SUBJECT: Notification of Class 1 Permit Modification to Update Figures in the Los Alamos National Laboratory (LANL) Hazardous Waste Facility Permit

**Class 1 Permit Modification to Update Figures in the Los
Alamos National Laboratory (LANL) Hazardous Waste
Facility Permit**

LA-UR-17-22537

Figure 29: TA-54, Area G, Pad 1

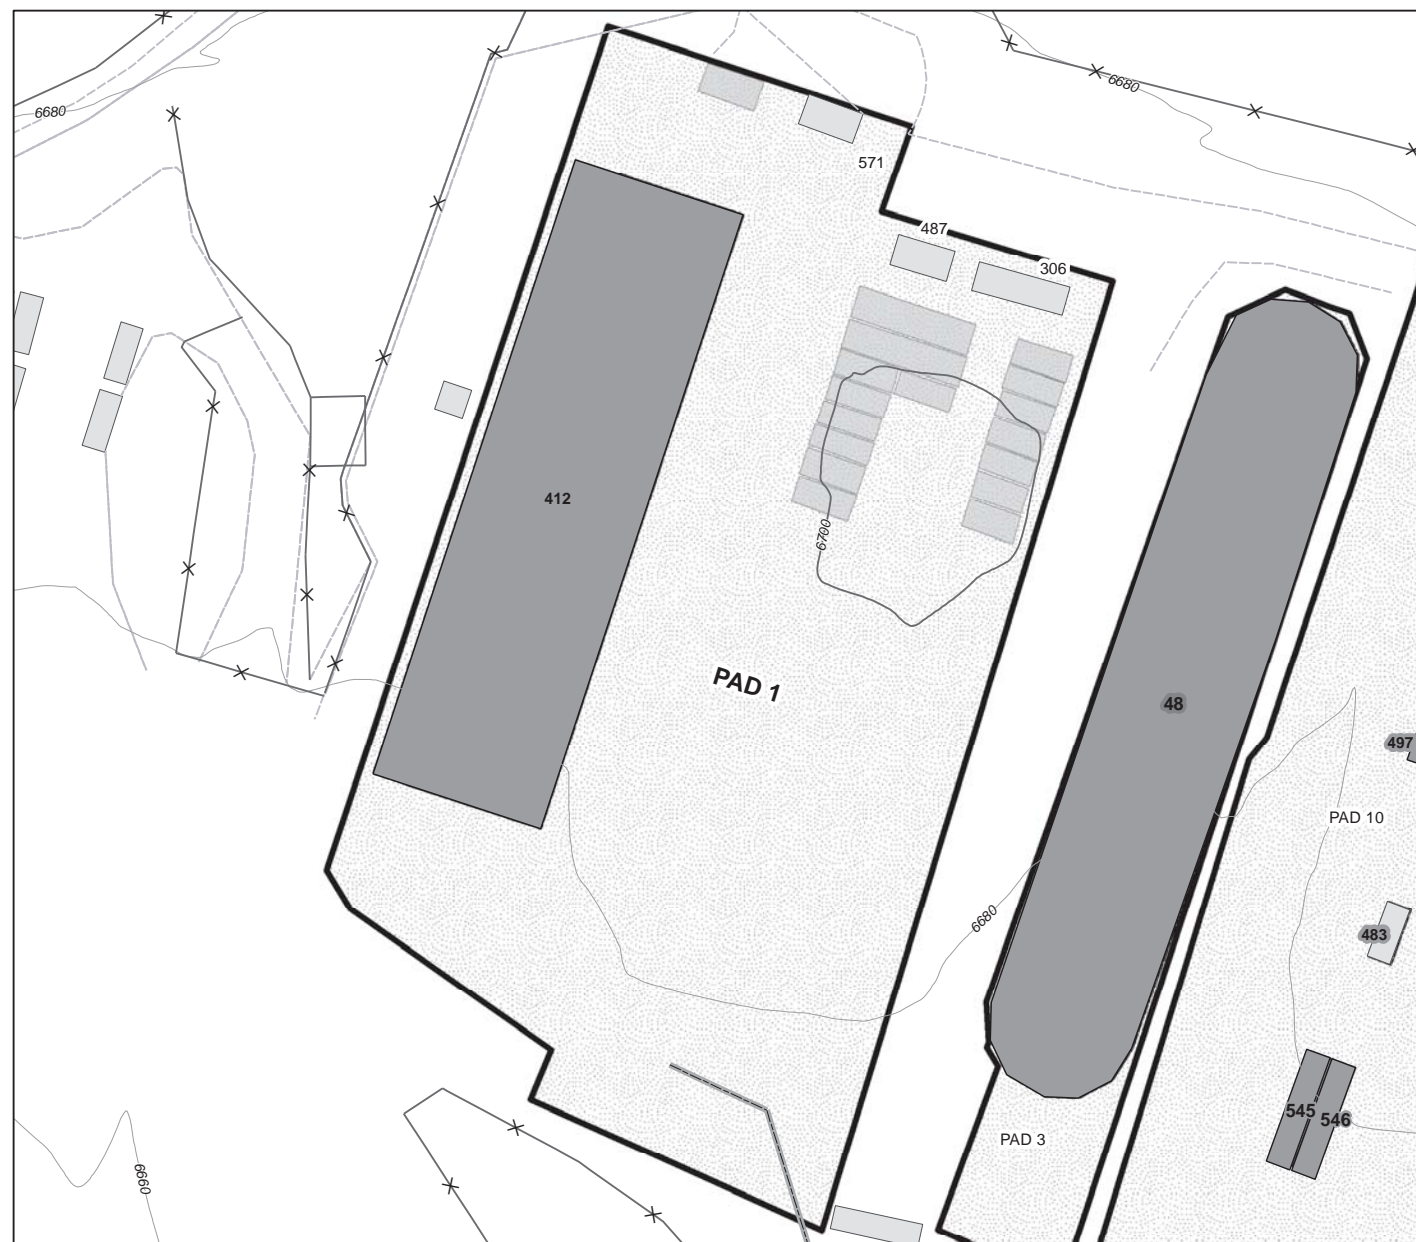
Figure 29 (*TA-54, Area G, Pad 1*) of Attachment N and Figure G.6-1 (*Technical Area 54, Area G, Pad 1 Outdoor Container Storage Unit Grid Sampling Locations*) of Attachment G.6 were revised to correctly reflect the number of support structures on Pad 1. The above mentioned figures were revised in a previous permit modification to include a total of 17 transportainers and storage sheds—which were to be situated on the permitted unit to serve as storage for tools and equipment. Only 16 containers were moved to the permitted unit; therefore, the additional storage structure has been removed from the revised figures.

- On Pad 1, a revision was made to correctly reflect the number of support structures. As was mentioned above, a previous permit modification included a total of 17 transportainers and storage sheds to be situated on the permitted unit; however, only 16 containers were moved. The polygon representing the additional storage structure has been removed.

Figure G.6-1: Technical Area 54, Area G, Pad 1 Outdoor Container Storage Unit Grid Sampling Locations

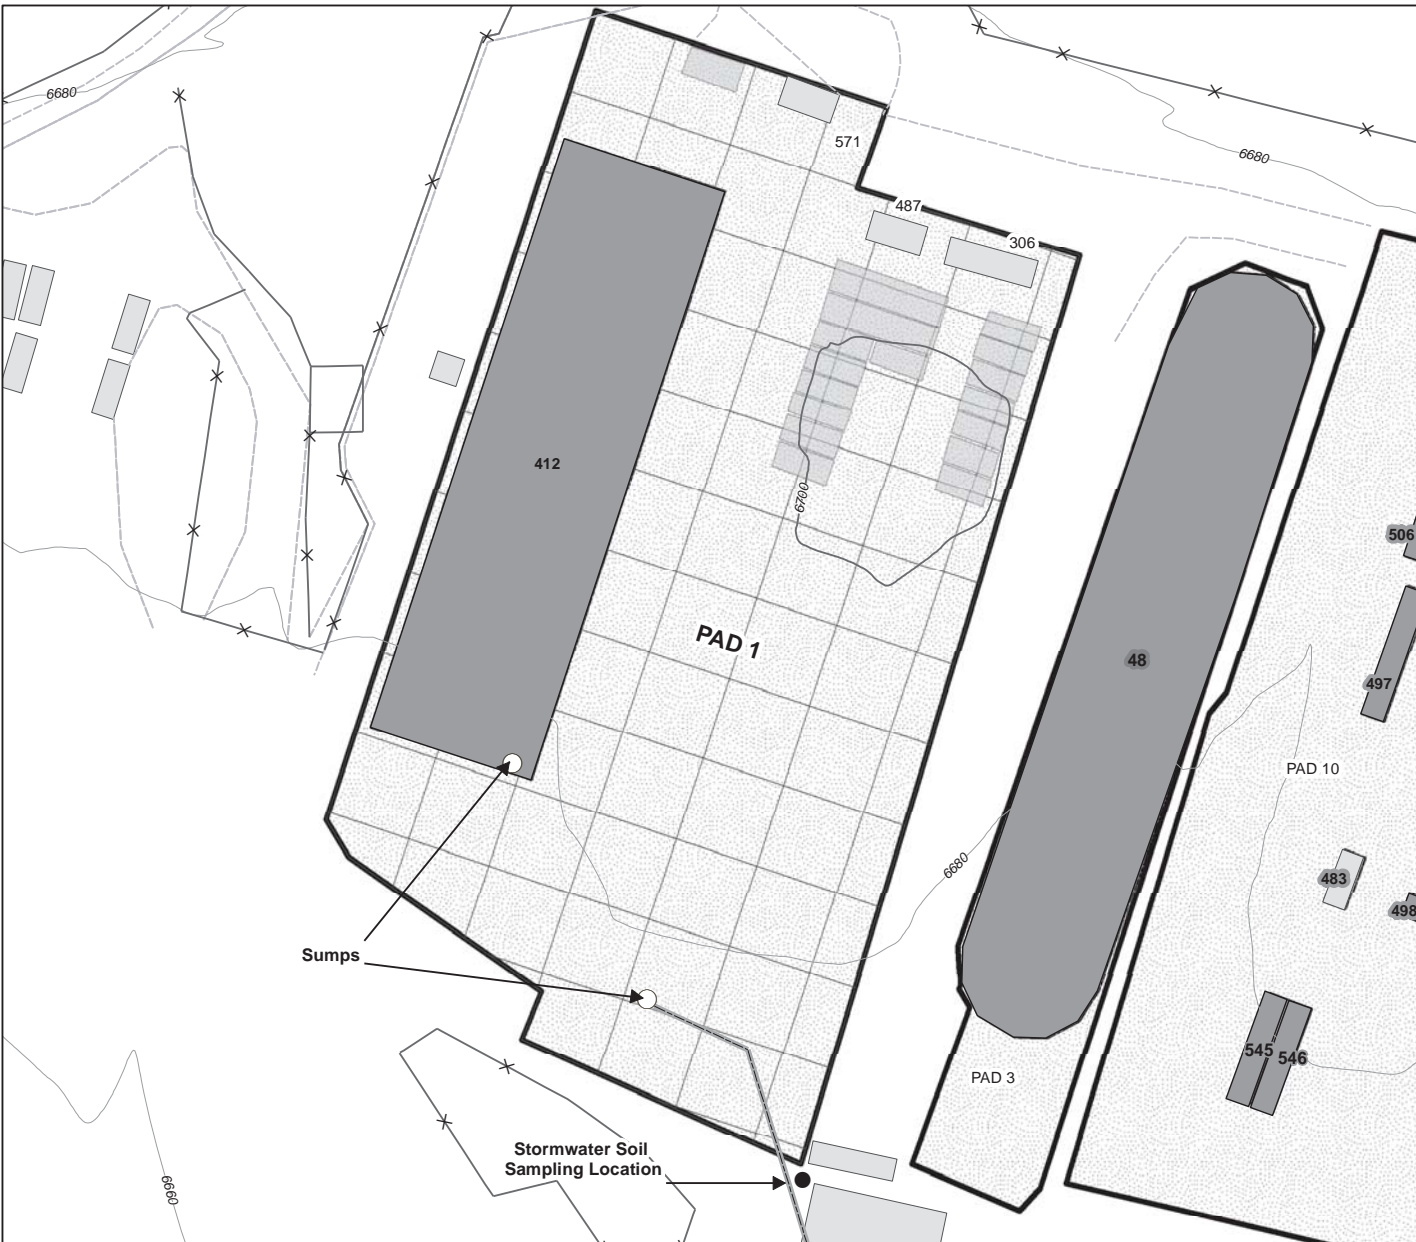
The title for Figure G.6-1, *Technical Area 54, Area G, Pad 1 Outdoor Container Storage Unit Grid Sampling Location*, which was inadvertently removed during a previous permit modification, was also added to the figure.

Figure 31: TA-54, Area G, Pad 10

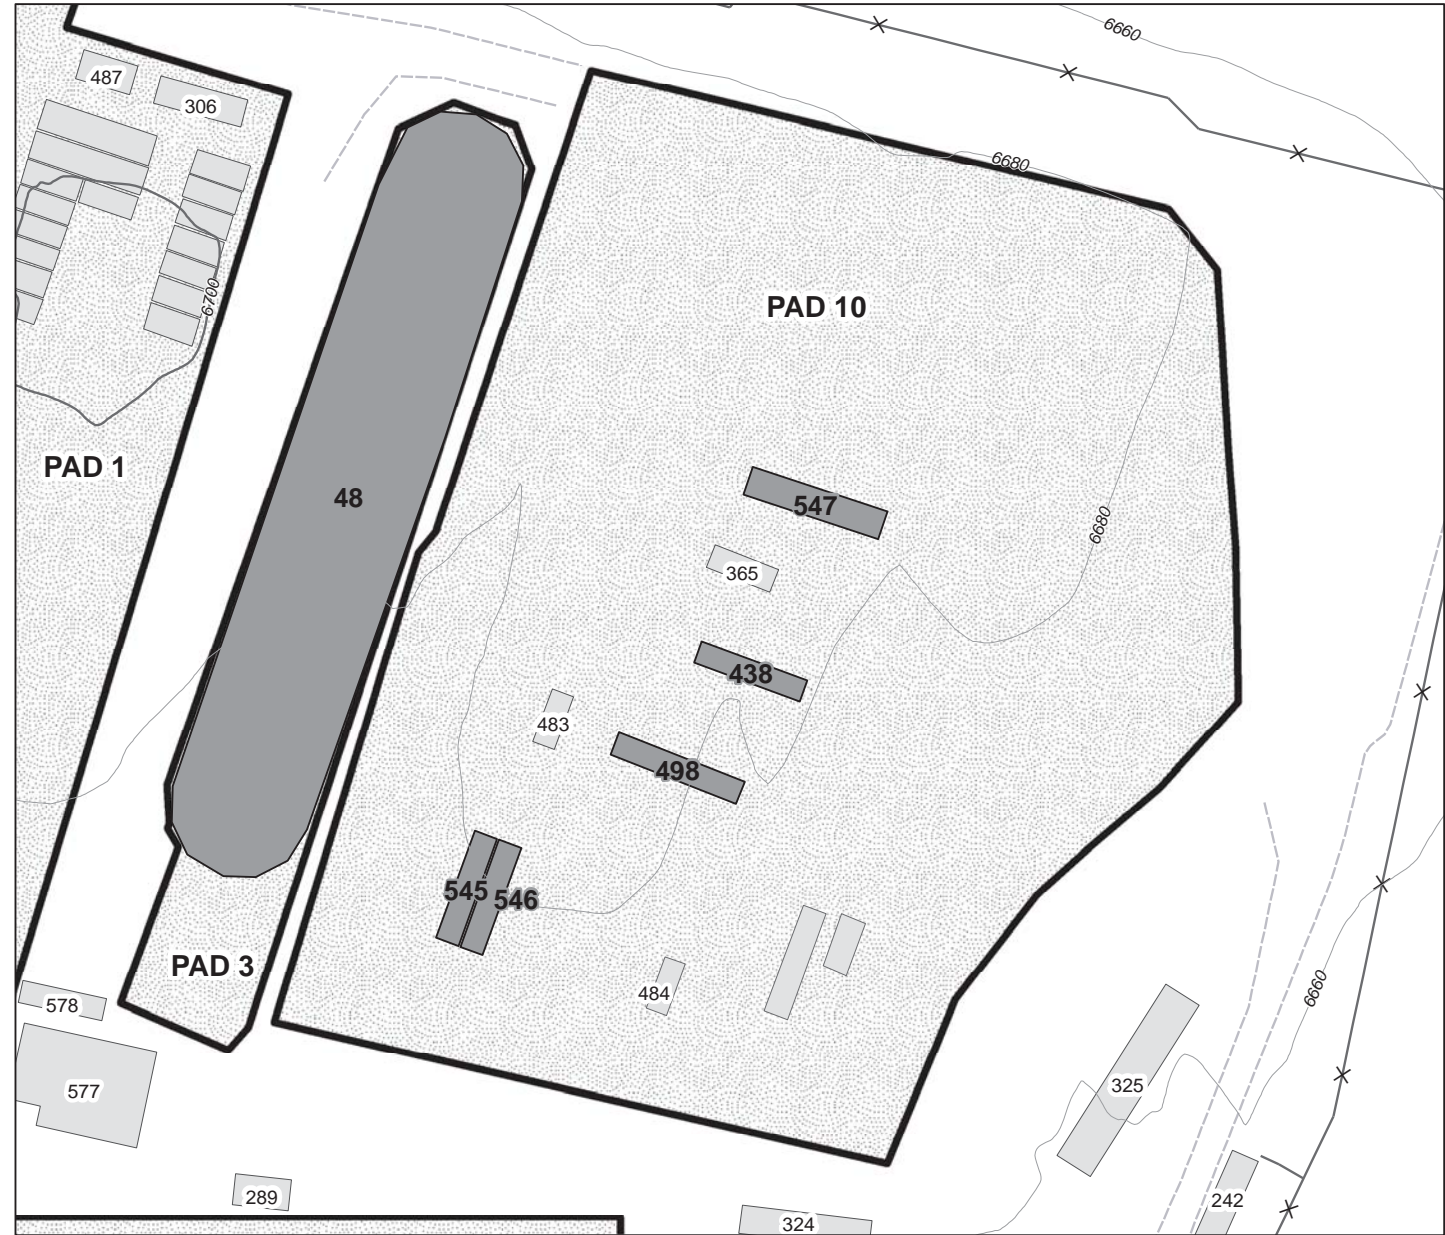
Figure 31 (*TA-54, Area G, Pad 10*) of Attachment N and Figure G.11-1 (*Technical Area 54, Area G, Pad 10 Outdoor Container Storage Unit Sampling Grid and Additional Sampling Locations*) of Attachment G.11 were revised to reflect the removal of a polygon/structure shown to be located at the north west corner of Pad 10, overlapping the permitted unit boundary. This polygon, which is an artifact from an outdated map layer, does not represent any existing structures/objects on the Pad.

G.11-1: Technical Area 54, Area G, Pad 10 Outdoor Container Storage Unit Sampling Grid and Additional Sampling Locations

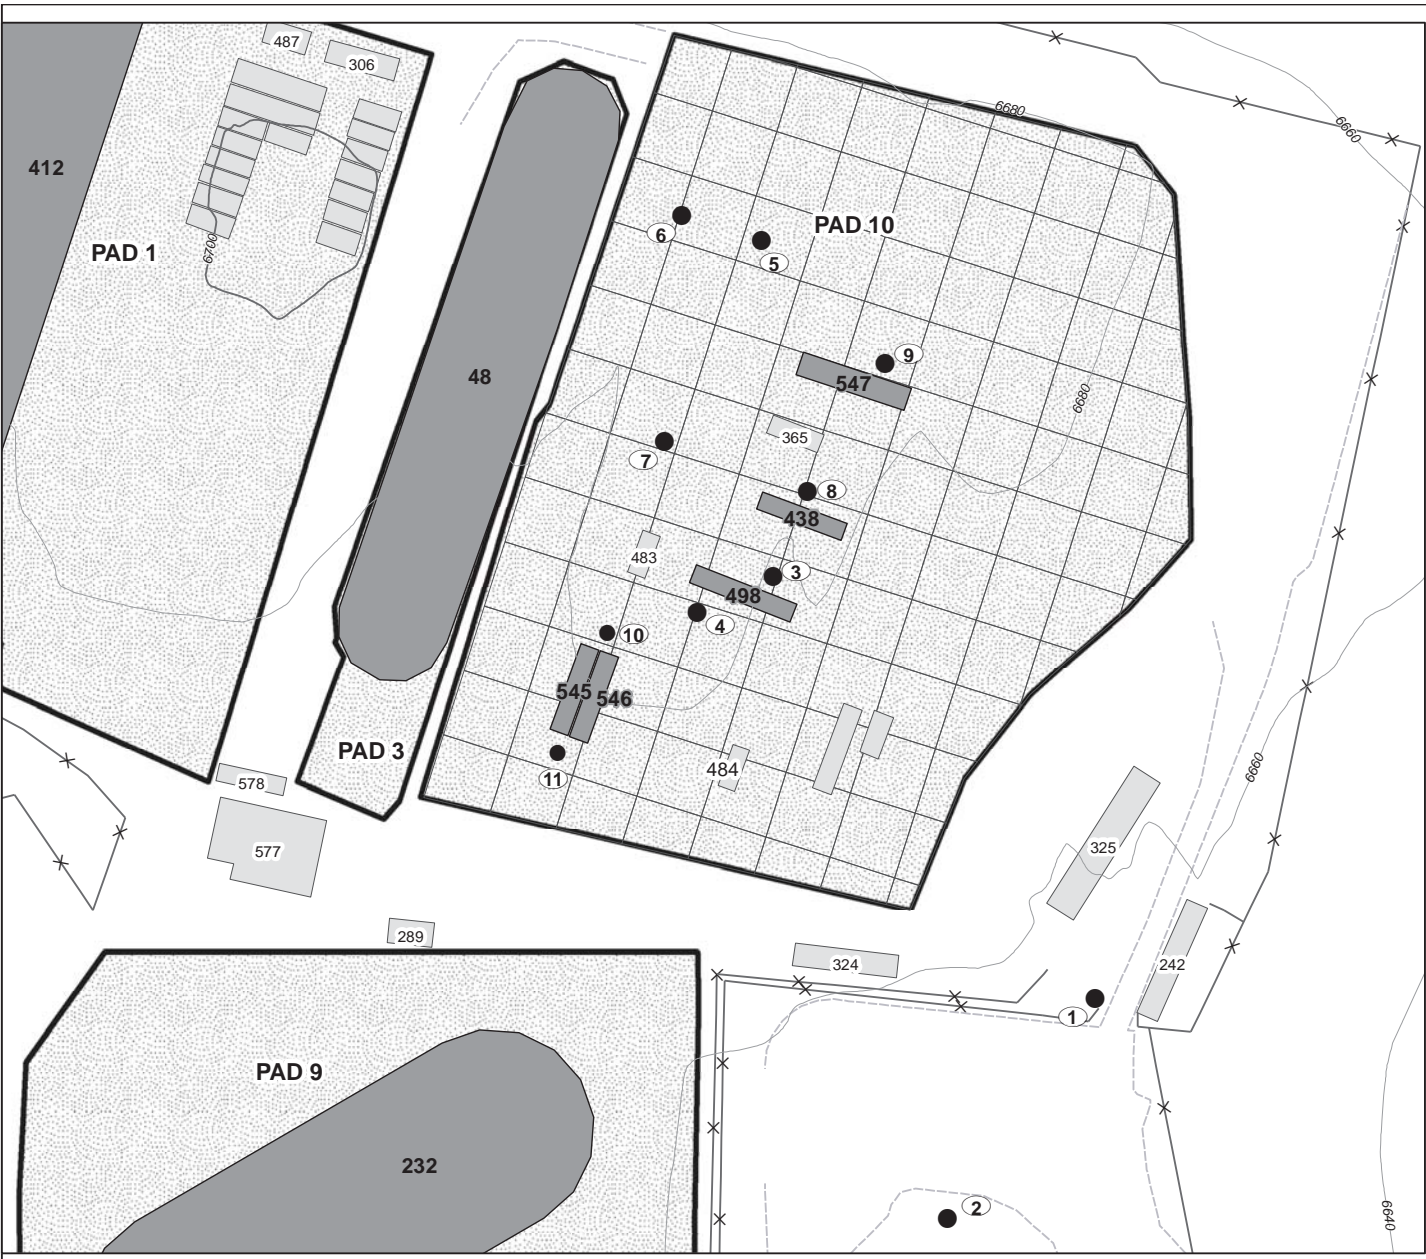
The title for Figure G.11-1, *Technical Area 54, Area G, Pad 10 Outdoor Container Storage Unit Sampling Grid and Additional Sampling Locations*, which was inadvertently removed during a previous permit modification, was also added to the figure.

Figure 36: TA-54, Area G, Pad 11

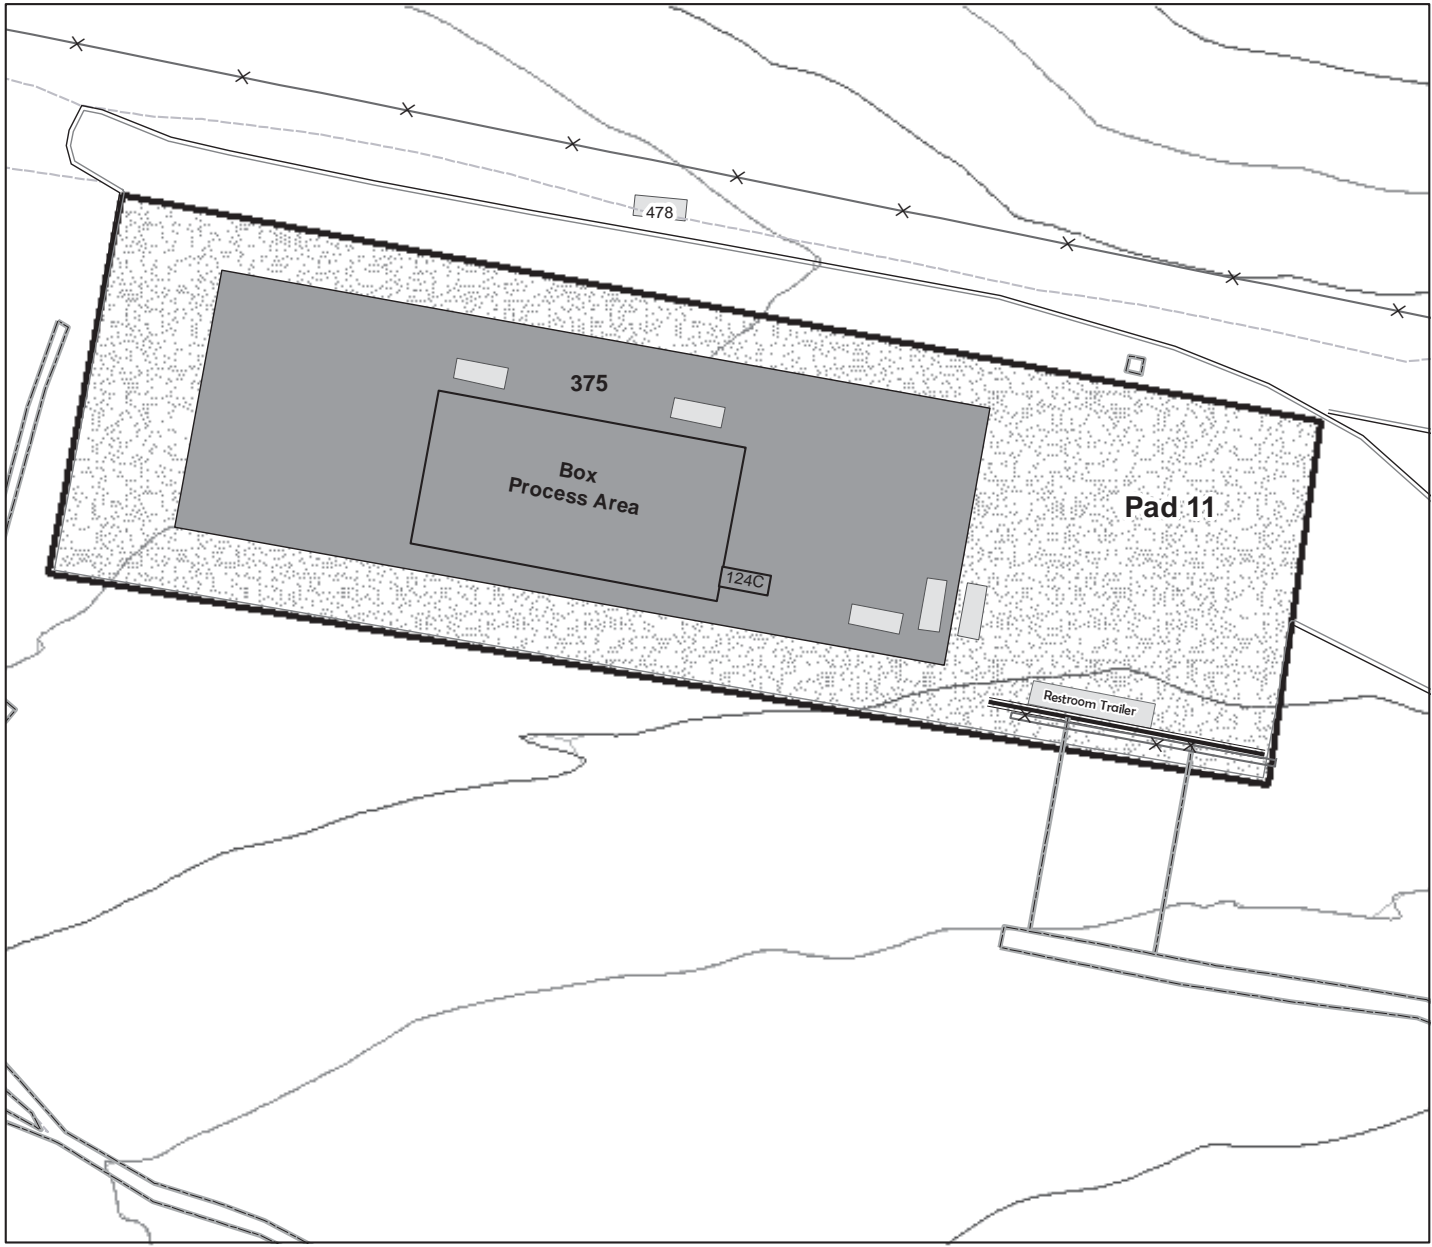
Figure 36 (*Technical Area (TA)-54, Area G, Pad 11*) of Attachment N and Figure G.12-1 (*Technical Area 54, Area G, Pad 11 Outdoor Container Storage Unit Grid Sampling and Additional Sampling Locations*) of Attachment G.12 were revised to accurately reflect the location and orientation of a restroom trailer that is located on Pad 11. Figure 36 and Figure G.12-1 currently show the restroom trailer as being oriented in the north-south direction; however, the restroom trailer is situated on the permitted unit in the east-west direction. The above mentioned figures have been updated to reflect this change.

Figure 36 and Figure G.12-1 were also revised to reflect the addition of a transportainer to the east Dome 375. This structure is situated on the permitted unit to serve as storage for tools and equipment; it will not be used to store or manage hazardous waste.
